**E-54 Regional Lift Station - RFCSP
Solicitation Number: CO-00537
Job No.: 22-2502**

**ADDENDUM 2
October 25, 2022**

SAWS JOB NO. 22-2502
 JOB NO. 11500-51
 DATE SEPTEMBER 2022
 DESIGNER KB
 CHECKED KB DRAWN GL
 SHEET E2.00

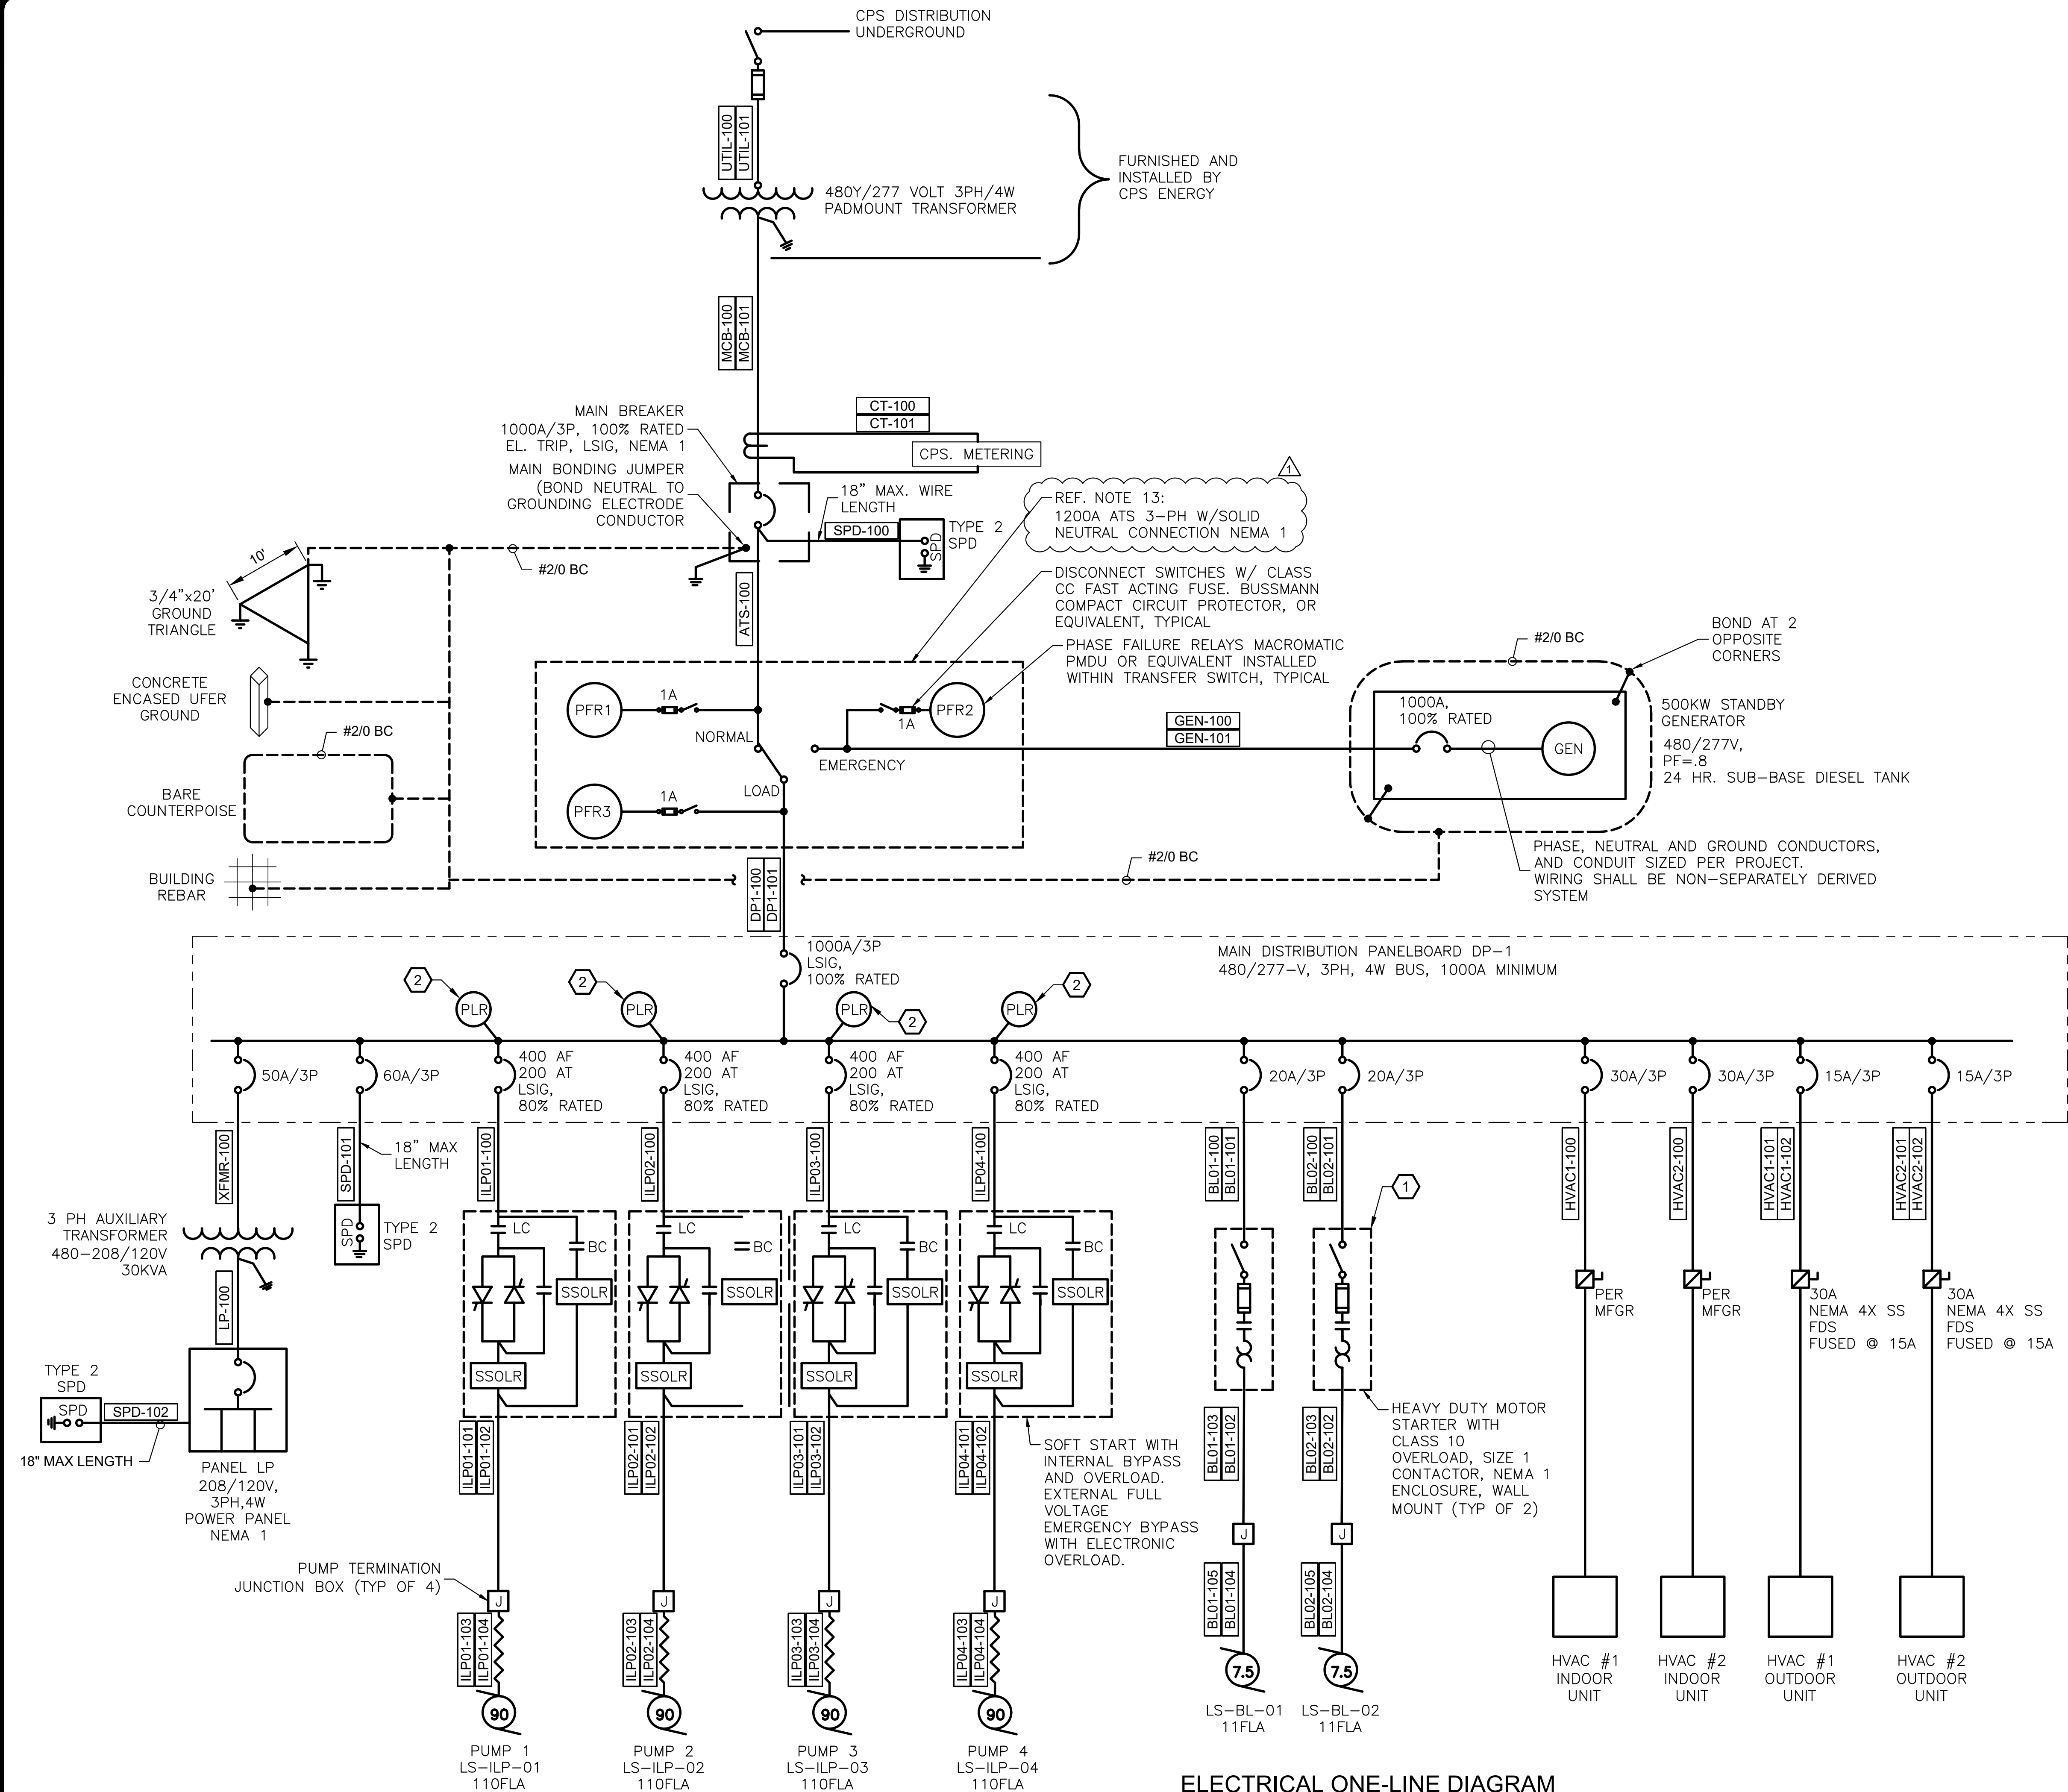
There is a discrepancy for the ATS between 1-line diagram stating 1000A rating and notes on Sheet E10.00 stating 1200A. Please clarify.

RESPONSE: Sheet E2.00 revised to show a 1200 amp ATS. See Changes to the Plans #6.

SAWS JOB NO.	22-2502
JOB NO.	11500-51
DATE	SEPTEMBER 2022
DESIGNER	KB
CHECKED	KB DRAWN
SHEET	E8.00

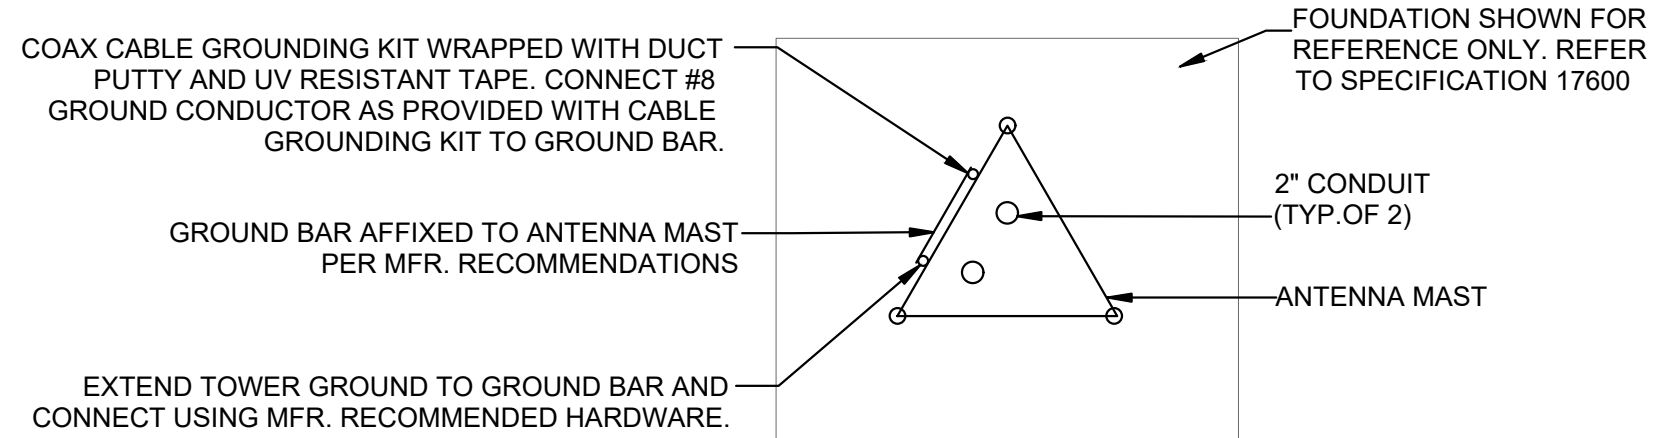
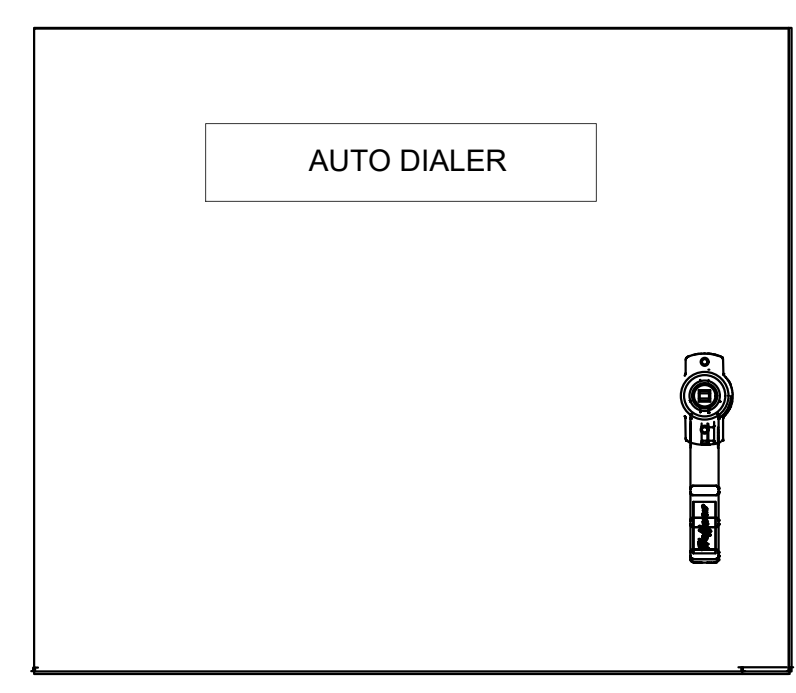
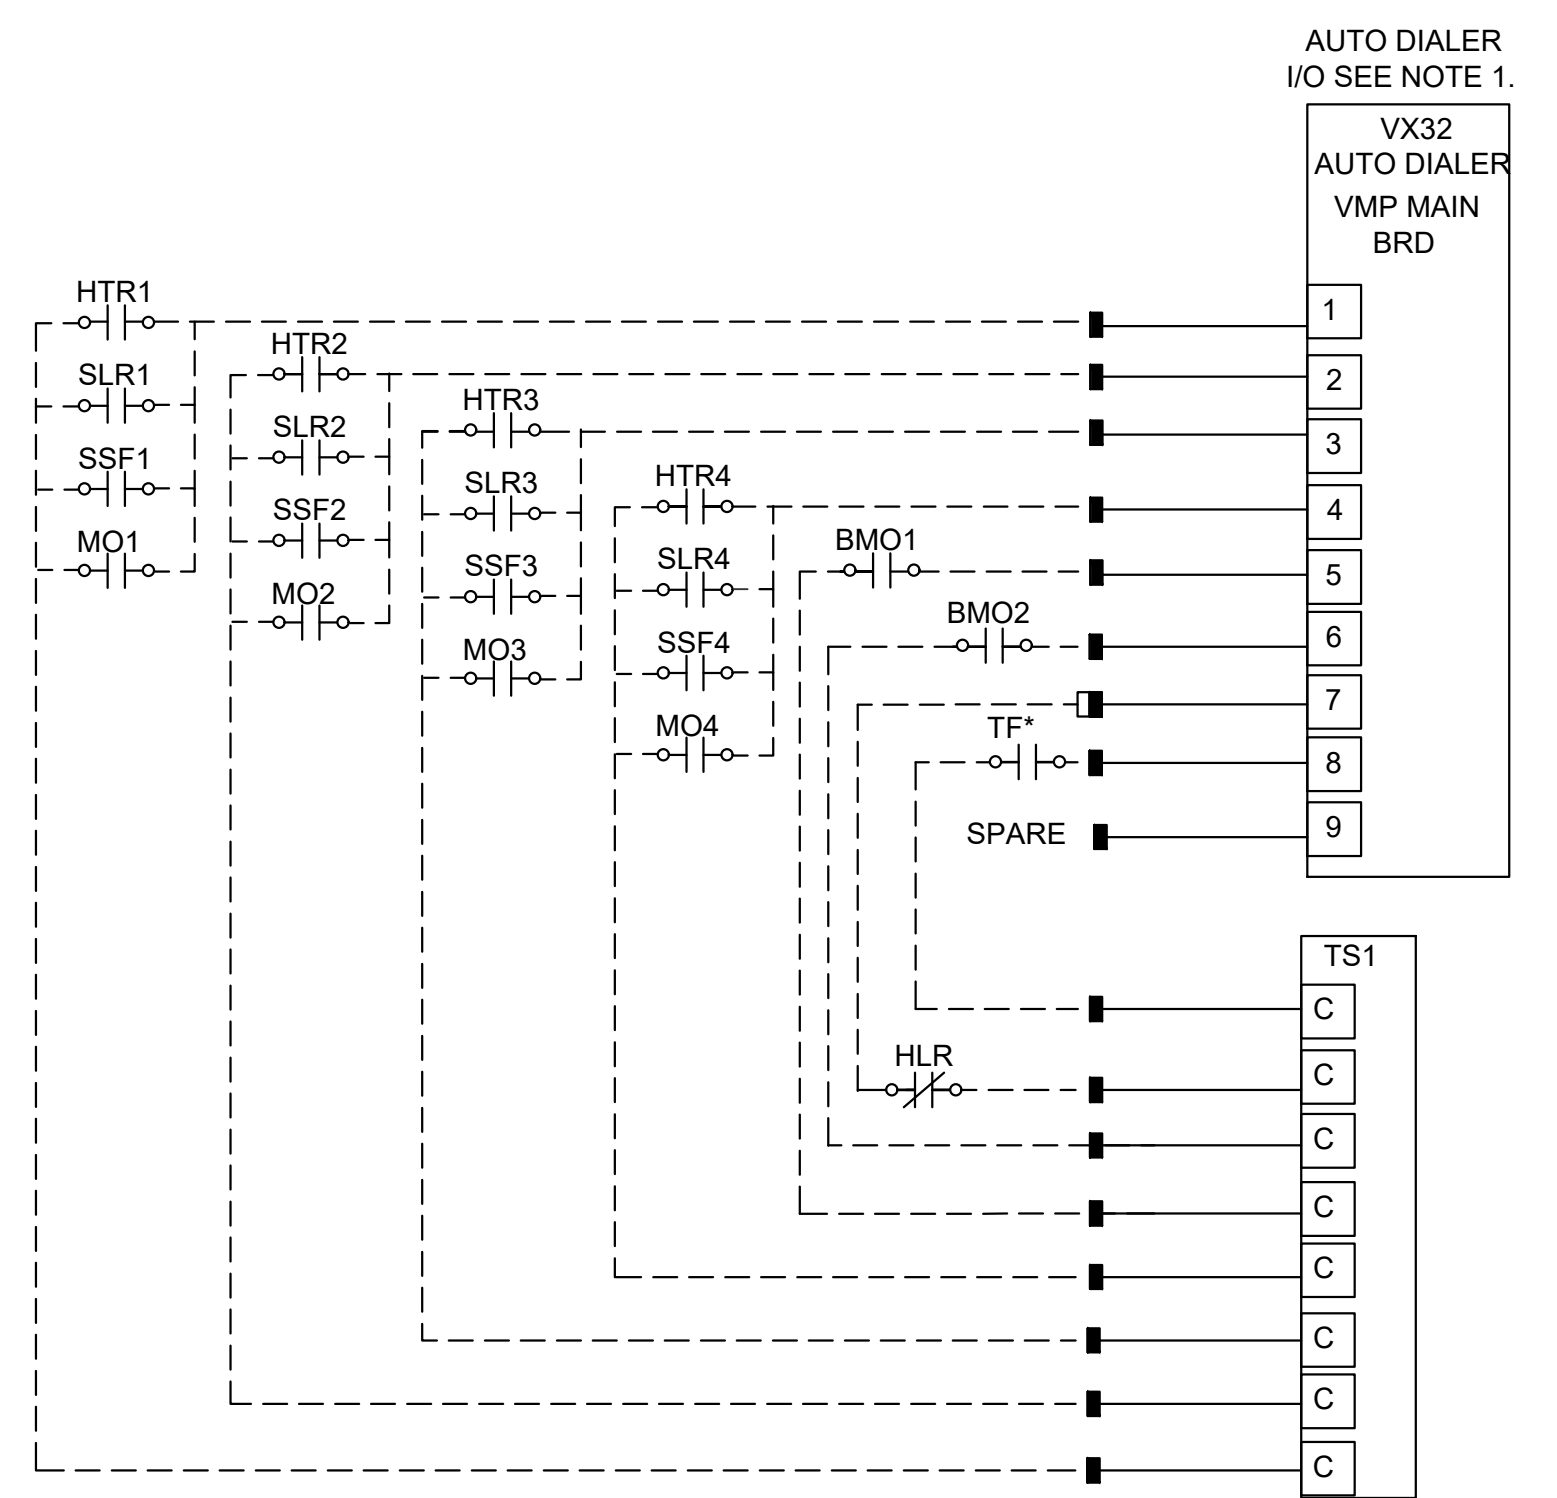
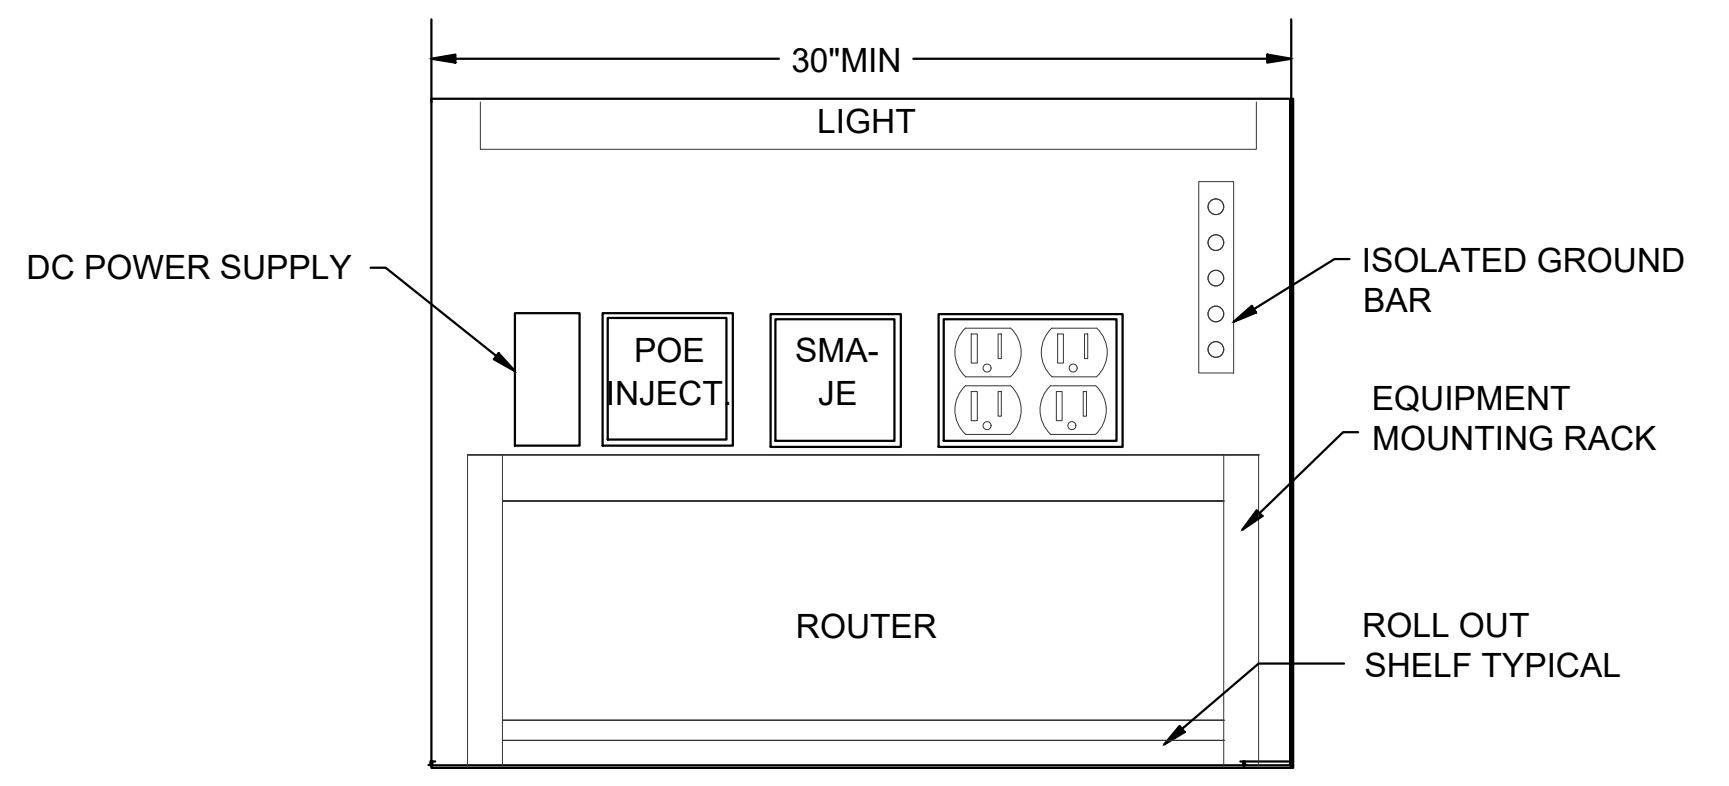
Is the antenna orientation correct?

RESPONSE: Revised antenna orientation is shown on revised sheet E8.00, ANTENNA ORIENTATION detail. See Changes to the Plans #10.
